PLANT NAME: H.B. Robinson # 2

RE: H. B. ROBINSON UNIT NO. 2
DOCKET NO. 50-261
FACILITY OPERATING LICENSE NO. DPR-23

Responses to Request for
Additional Information Transmitted by NRC
Letter of September 30, 1975

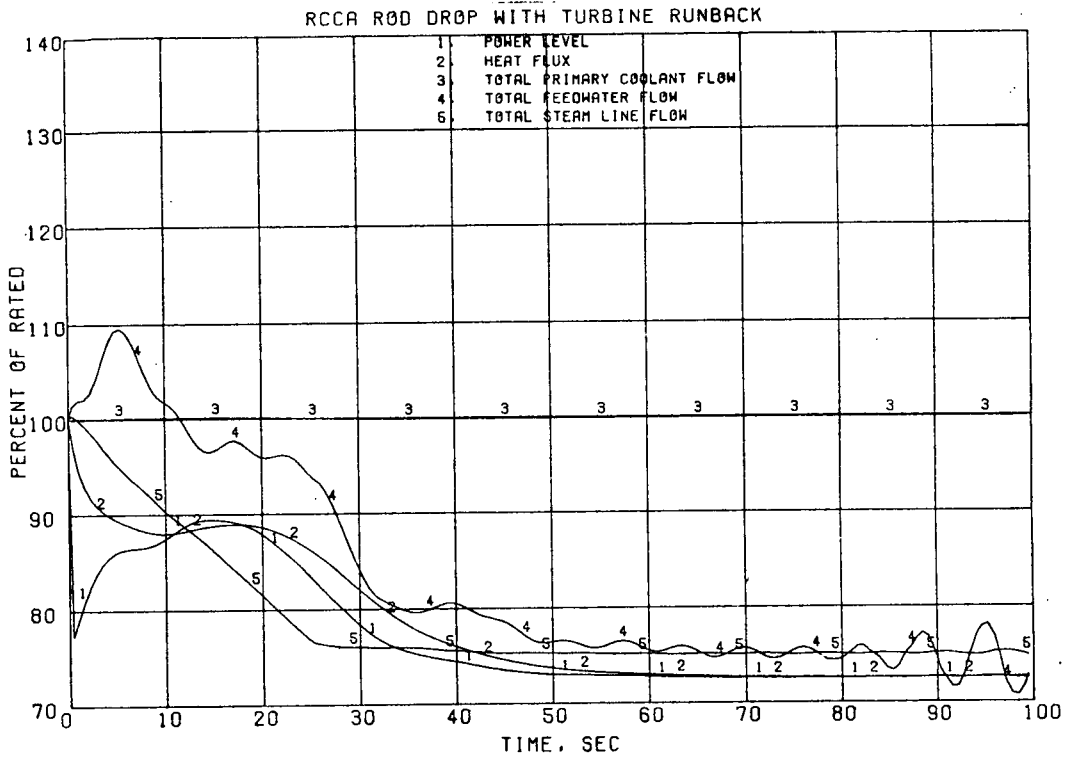
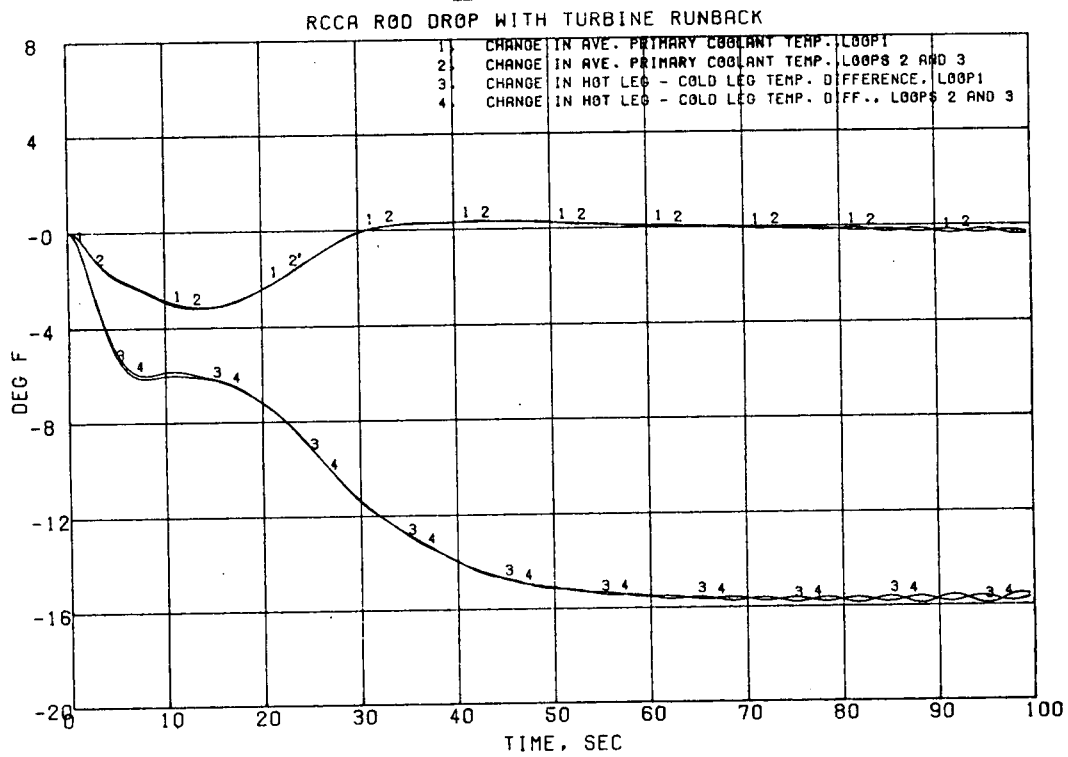
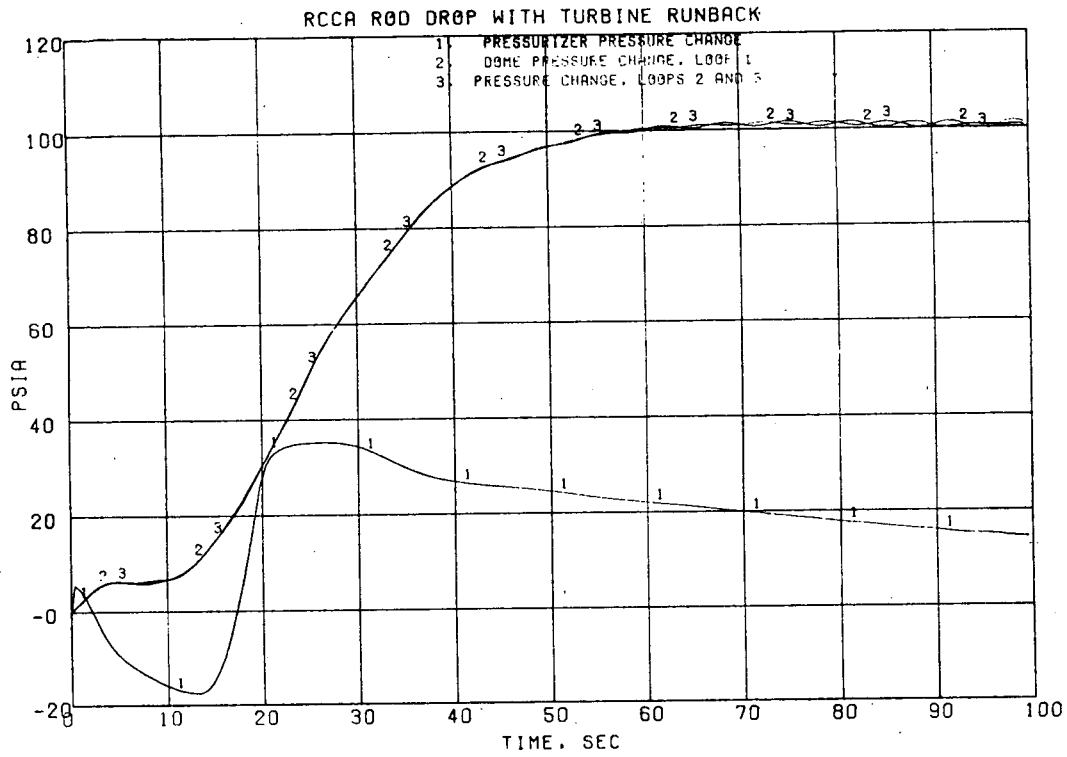
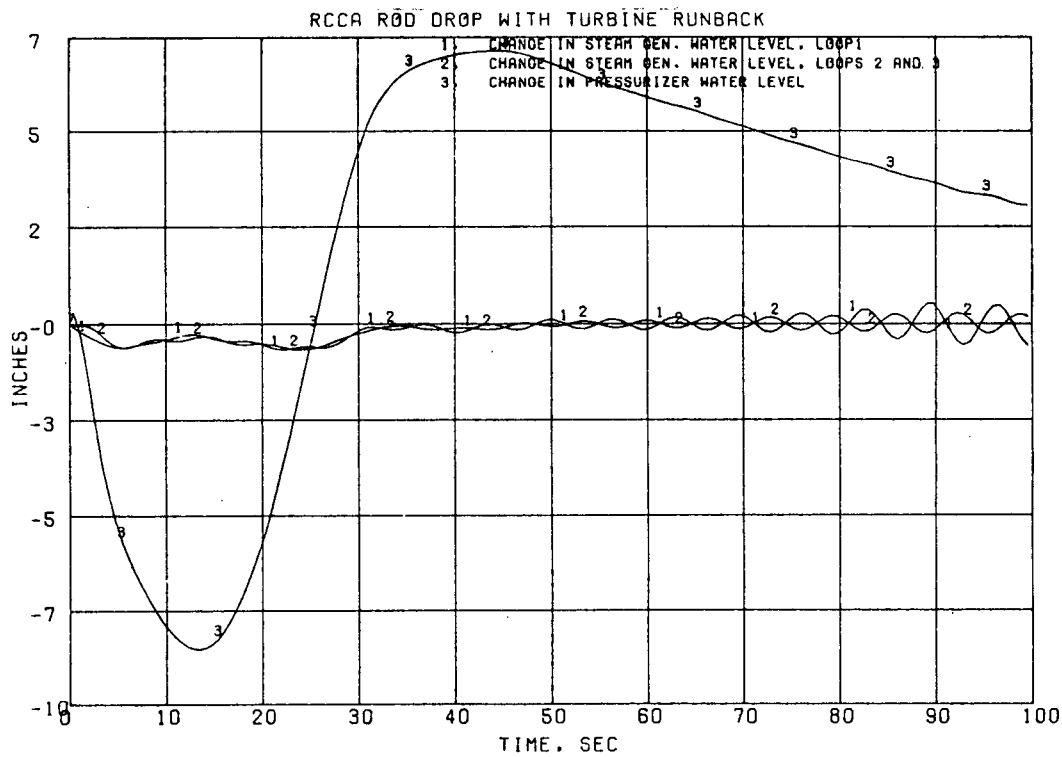
Provide an analysis of the consequences of the RCCA drop presented in Section 3.2 of XN-75-14 if automatic turbine cutback does not occur. Also, what happens if the system is under manual control, and control rods are withdrawn to maintain power?

The results of a transient analysis with both of the above actions occurring are depicted in Figures 1-1 through 1-4. The reactor does not return to power. The peak heat flux reaches 89% of rated, and MDNBR does not fall below its initial value.

Figure 4-1

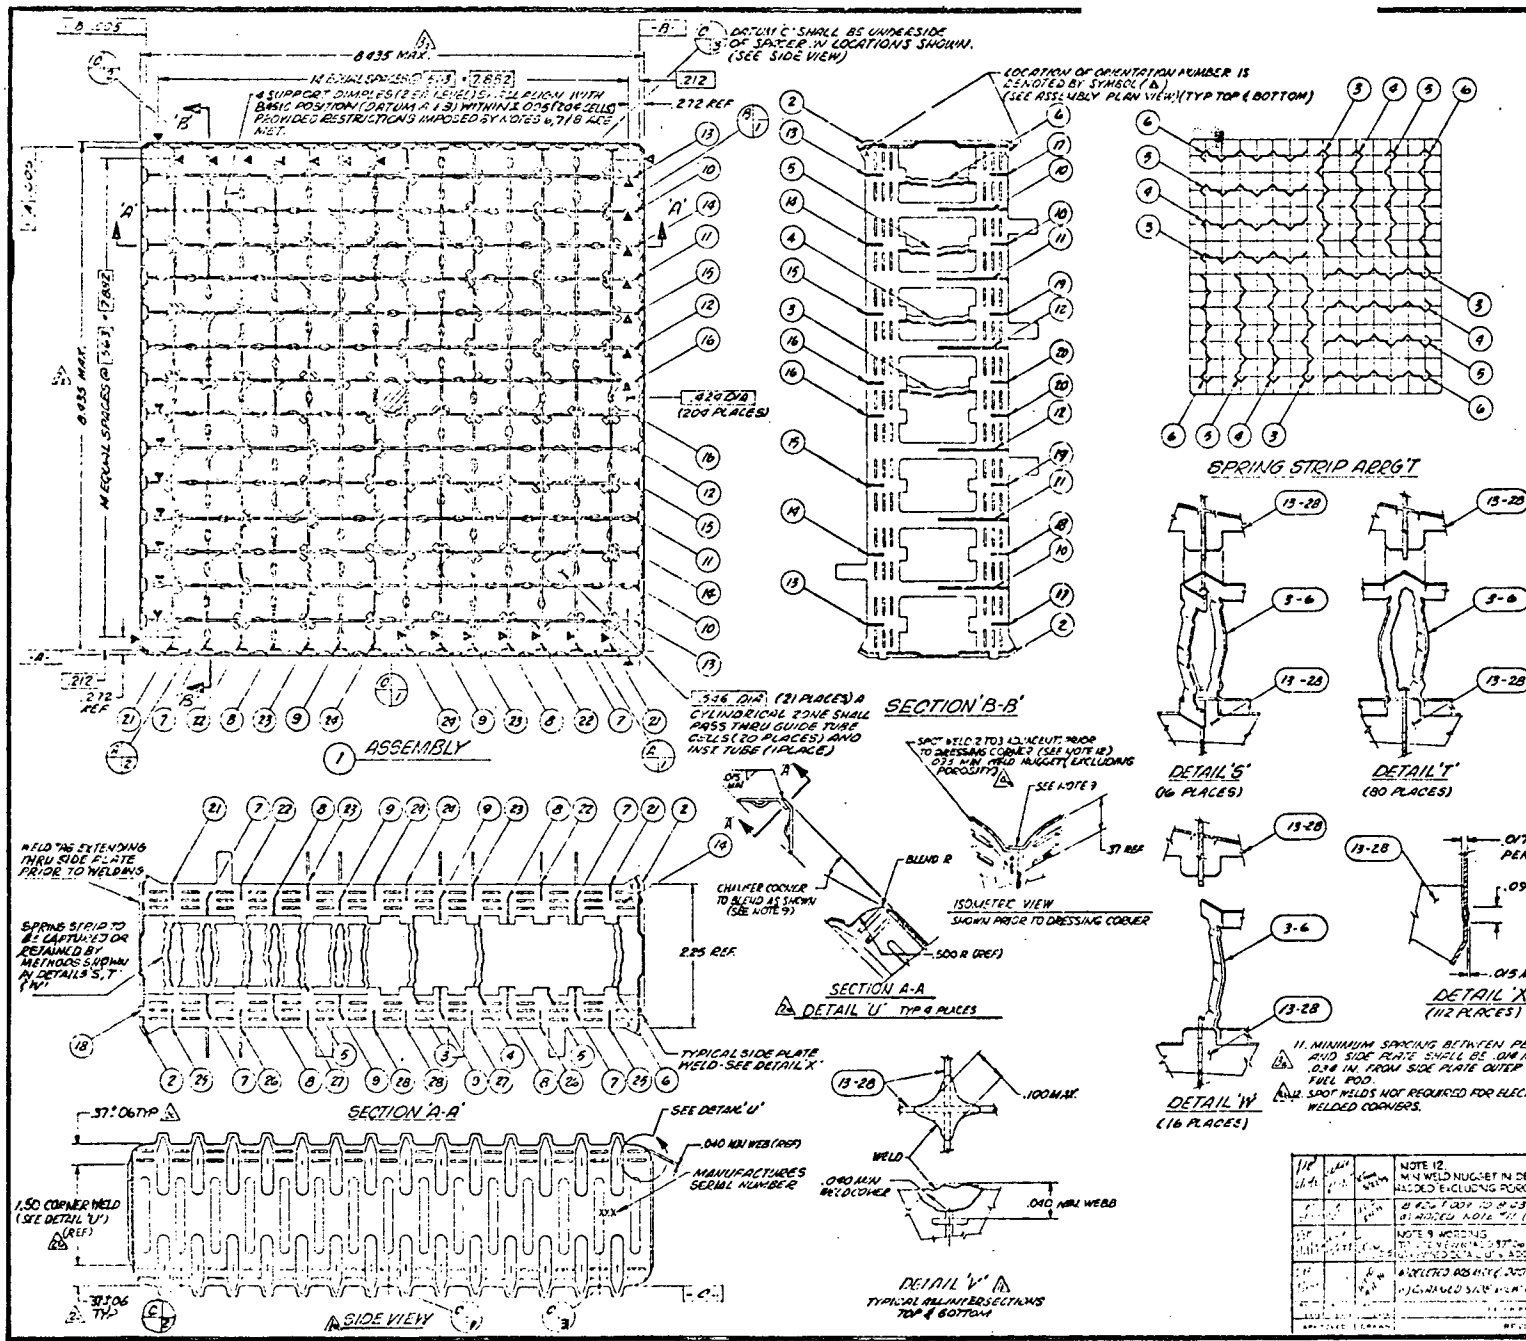
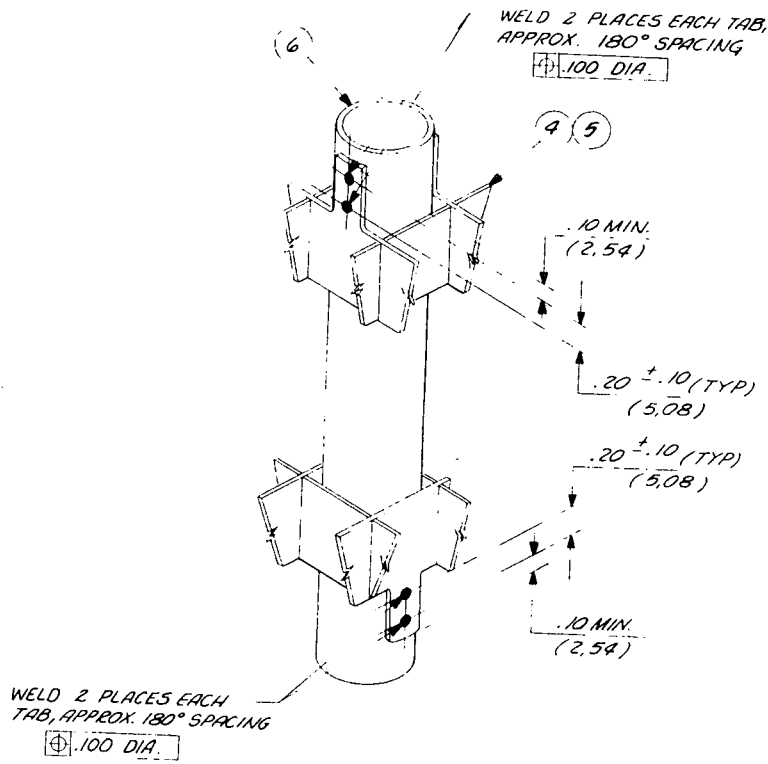
Provide a drawing of the spacer grid assembly design which in particular shows the details of the Zr-4 grid strips and Inconel spring strips. What other differences are there between the Exxon and Westinghouse spacer grid assembly designs?

Details of the Zircaloy-4 grid strips and Inconel springs are shown in Figure 4-1. The basic differences between ENC and Westinghouse grid spacer designs are as follows:

- 1) has greater depth
- 2) is welded versus brazed
- 3) has one versus two springs per cell
- 4) bi-metallic design

GUIDE TUBE TO SPACER ATTACHMENT

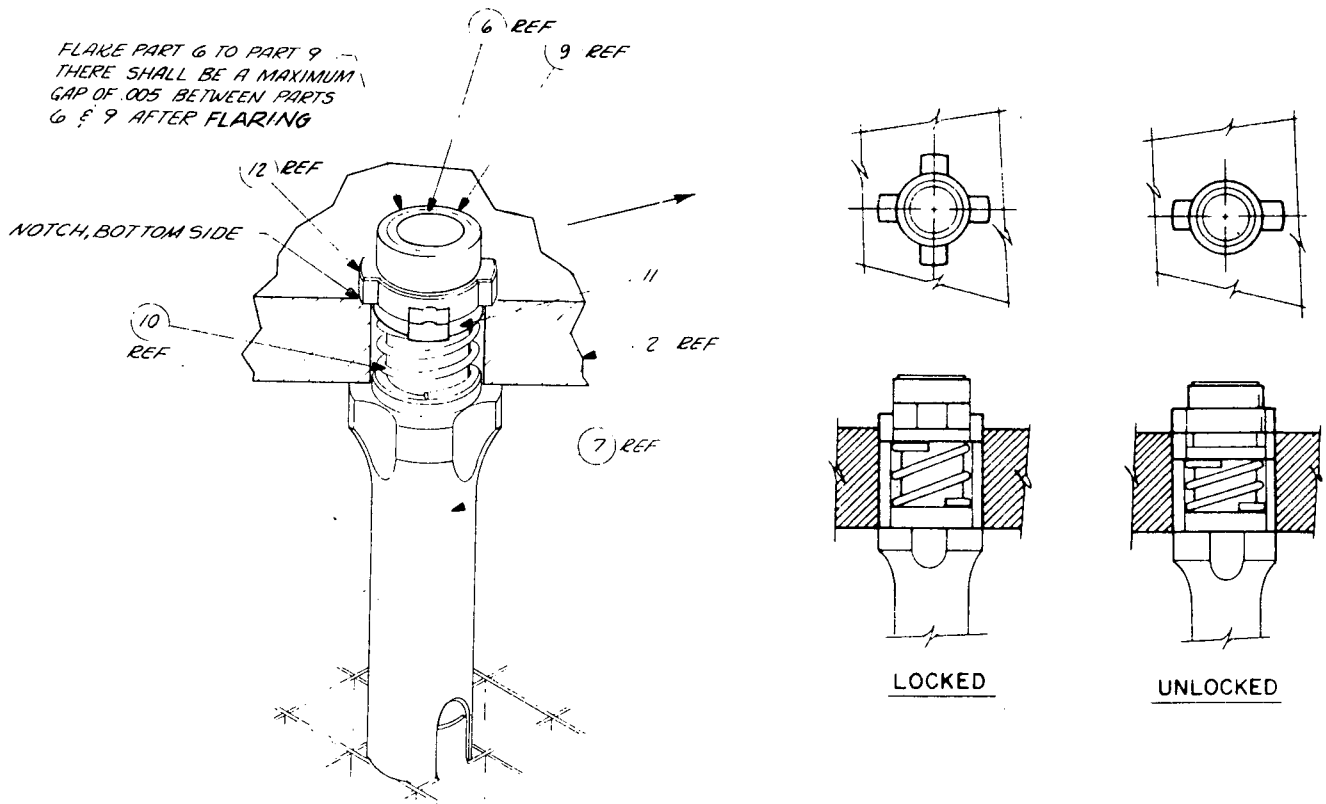
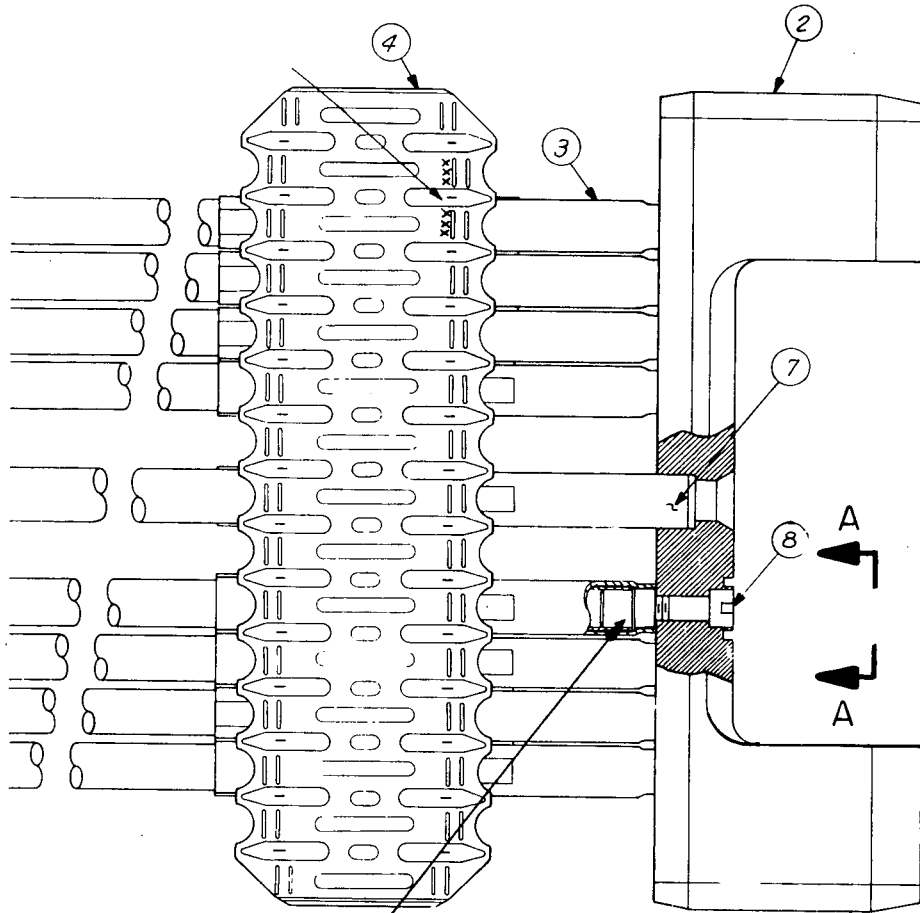
What method of attachment between the spacer grids and the guide tubes is used?

Provide a drawing which shows the method of attachment of the control rod guide tubes to the upper and lower grid plates and the method of attachment of the spacer grids to the control rod guide tubes. Describe any differences between the Exxon design and the Westinghouse assemblies currently in HBR in these areas.

Grid spacers are capacitance resistant welded to the guide tubes. Four weld tabs are provided on the spacer at each guide tube location. Details are shown in Figure 5-1.

Details of attachment of guide tubes to the upper tie plate, lower tie plate and grid spacers are shown in Figure 5-1.

Figure 9-1

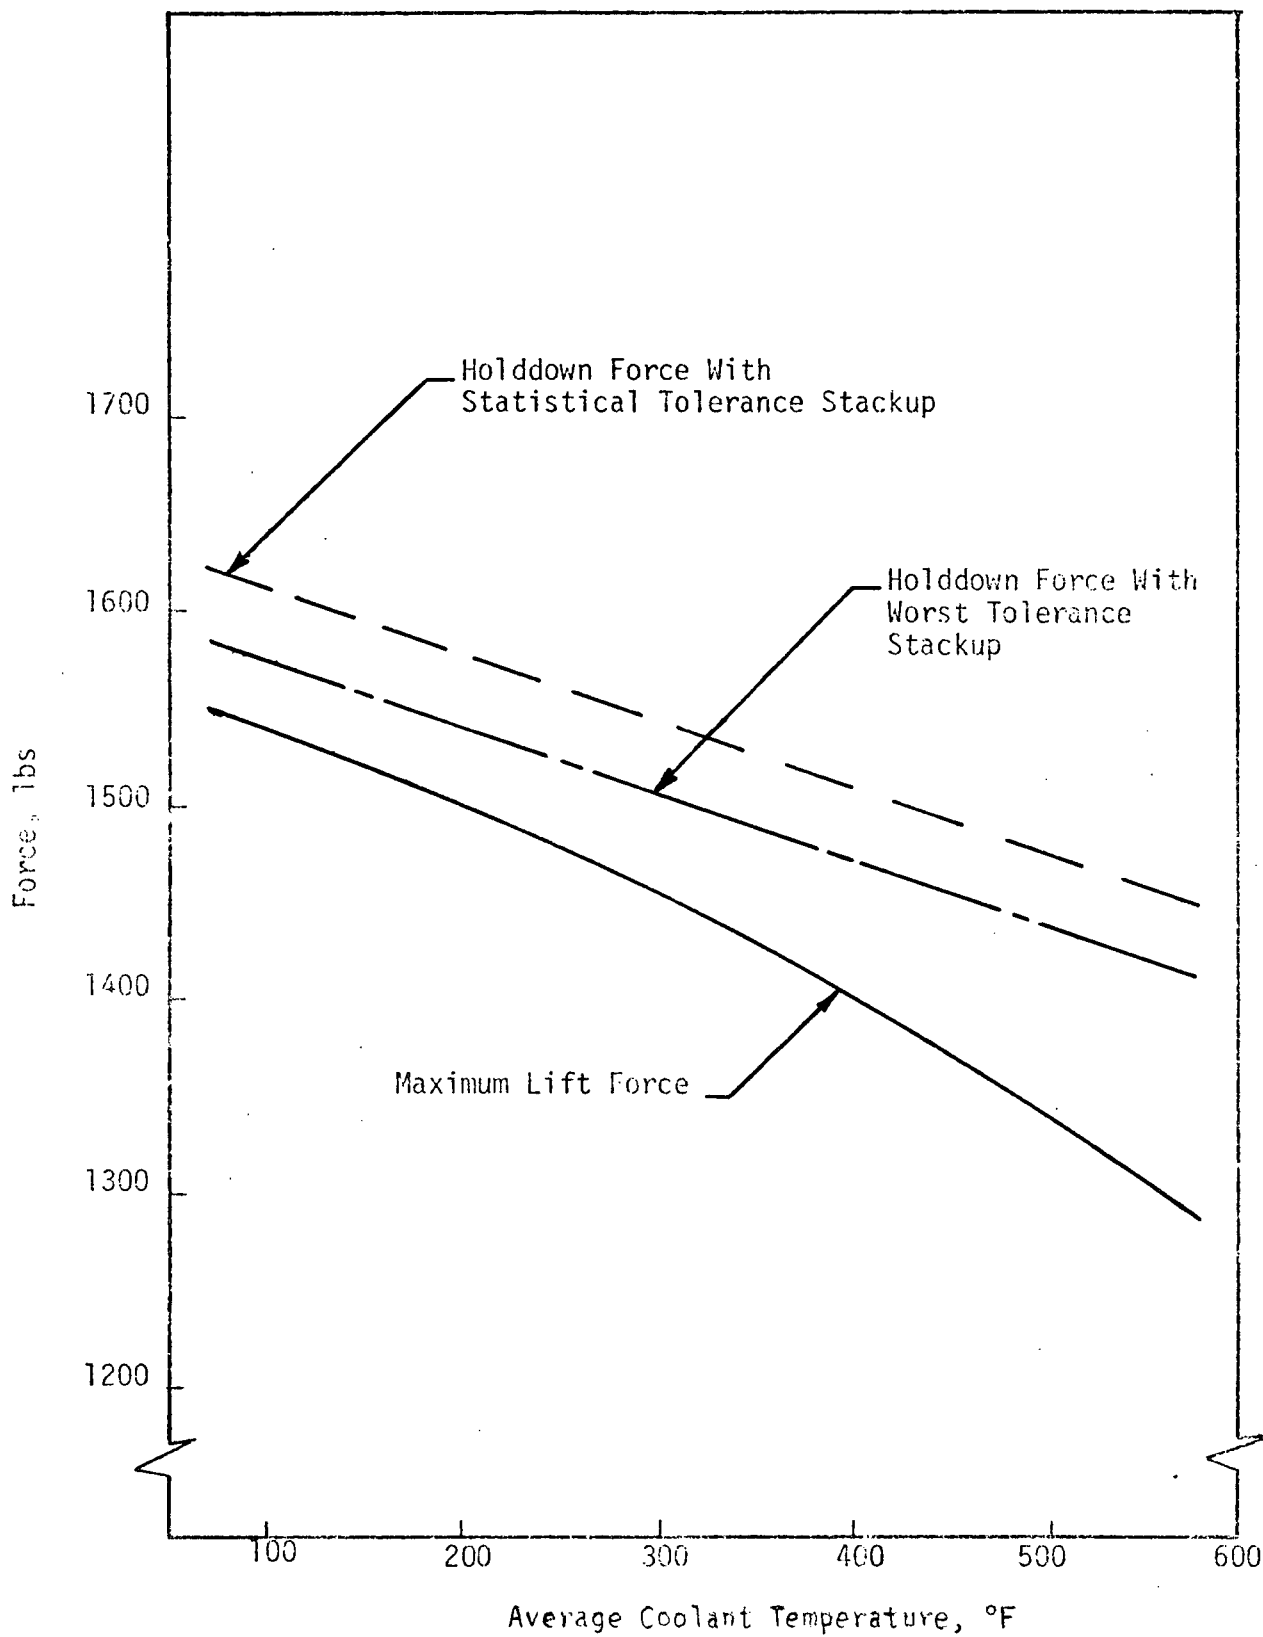
Provide an analysis or thermal hydraulic test data which shows the design adequacy of the holddown forces provided by the four leaf springs located in the upper grid plate in preventing fuel assembly liftoff.

The estimated lift force on the assembly, based upon ENC prototype ΔP tests and information furnished by the reactor supplier, is illustrated in Figure 9.1 and is a function of operating temperature.

Figure 9-1 shows the total holddown load (spring load plus immersed assembly weight) for the improbable case illustrated above where tolerances are stacked up in the most conservative way and also for the more probable case where the tolerances are stacked up on a statistical basis.
